Re: Application Ref: 2016/4457/P: Objection To Proposed Replacement Of Horizontal Aluminium Sliding Sash Windows With Polyester Powder Coated Aluminium Casement Windows

RE: APPLICATION REF: 2016/4457/P: OBJECTION TO PROPOSED
PLANNING APPLICATION: REPLACEMENT OF HORIZONTAL ALUMINIUM
SLIDING SASH WINDOWS WITH POLYESTER POWDER COATED
ALUMINIUM CASEMENT WINDOWS

(Windows at Flat 2d Millman Street, London WC1N 3EB)

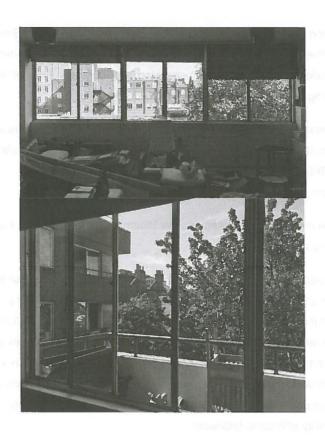
A notable feature of the buildings is the aluminium sliding windows. These are an integral element of the original design and are a 'trademark' element of Farrell and Grimshaw's work. For example, the windows of Grimshaw's iconic Park Road Apartment development in St John's Wood completed in 1968 http://grimshaw-architects.com/project/park-road-apartments/ are identical to those at 1-19 Millman Street/Place.

See images of the Millman Street windows below for comparison.

As stated earlier, the aluminium sliding windows are integral to the design of the estate. The appearance of the building, which is of historic interest would be harmed by the removal of this original architectural feature.

- Before proceeding Camden should provide proper justification for window replacement rather than refurbishment,
- If there a convincing justification for replacement is provided, we request that the windows should be replaced 'like for like' both in design and quality as per Camden's own good practice principles for windows⁶:
